intel® Technical Advisory

TA-799-1

Intel® Server Chassis SR1450 Drive Bay Interference with the AXXFLOPHDDTRAY (Hard-Drive-to-Floppy Conversion Kit) Accessory

1. Removal of the drive carrier stop pin

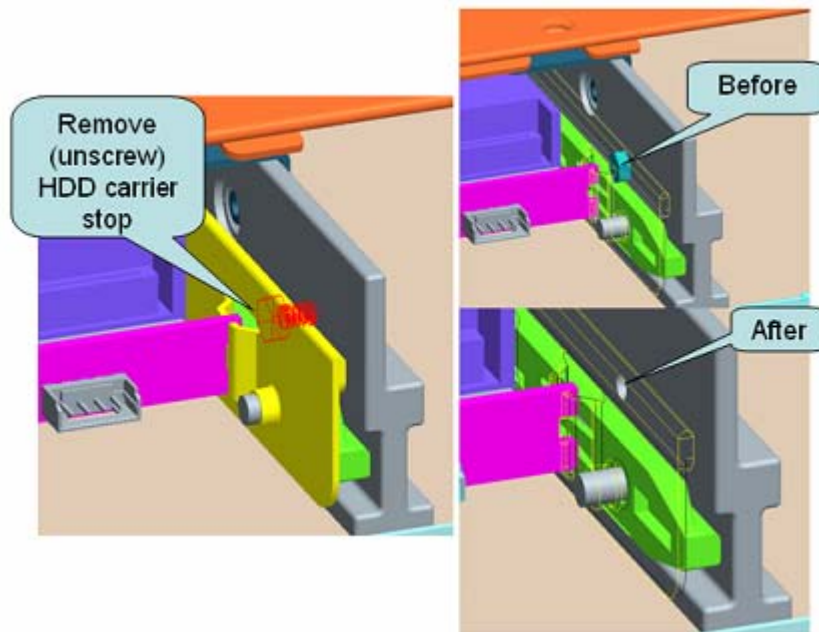
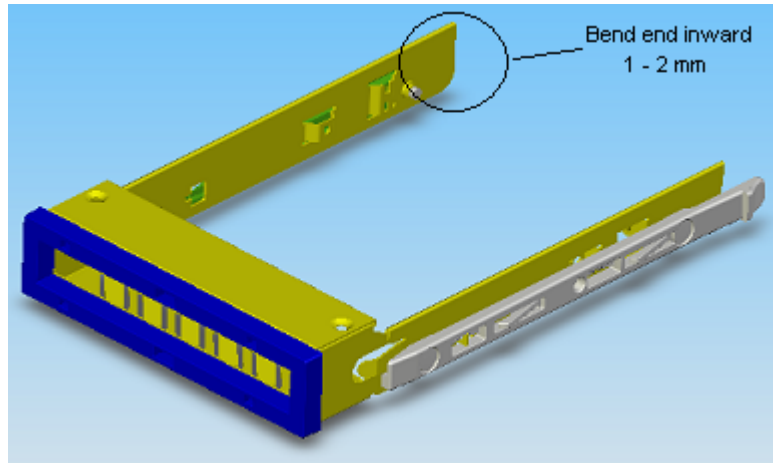
The interference is created by a drive carrier stop pin inside the drive bay of the Server Chassis SR1450. The stop pin interferes with the cage of the Hard-Drive-to-Floppy Conversion Kit and prohibits its full insertion into the server chassis.

The drive carrier stop pin in the drive bay of the SR1450 may be safely removed to allow the full insertion of the Hard-Drive-to-Floppy Conversion Kit as follows:

- Remove the Server Chassis SR1450 cover and front outer bezel (if present).
- Remove any hard disk drive or carrier from the middle drive bay of the chassis.
- Viewing from the rear of the Server Chassis SR1450, locate the carrier stop pin in the rail assembly of the middle drive bay.
- Using needle-nose pliers, grasp the drive carrier stop pin and unscrew it from the drive bay as shown.

- Push the Hard-Drive-to-Floppy Conversion Kit into the chassis until it is completely installed in the Server Chassis SR1450 (clicks into place).
- Complete the installation according to the instructions contained in the conversion kit.

2. Flexing the cage of the conversion kit during installation.

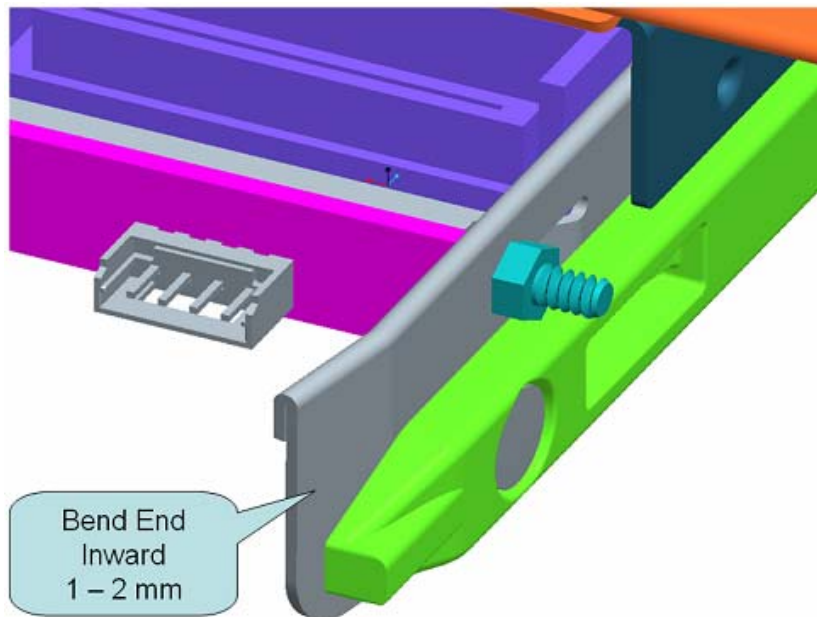
The conversion kit may be flexed during installation to allow its insertion in the chassis as follows:

- Remove the Server Chassis SR1450 front outer bezel (if present).
- Insert the cage of the Hard-Drive-to-Floppy Conversion Kit into the middle drive bay and push until it meets the stop pin.
- While pushing the Hard-Drive-to-Floppy Conversion Kit into the chassis, gently bend the left metal rail of the cage approximately 1 to 2 millimeters inward, as shown.

- Continue pushing the Hard-Drive-to-Floppy Conversion Kit into the chassis until the kit is completely installed (clicks into place) in the Server Chassis SR1450.
- Complete the installation according to the instructions contained in the conversion kit.
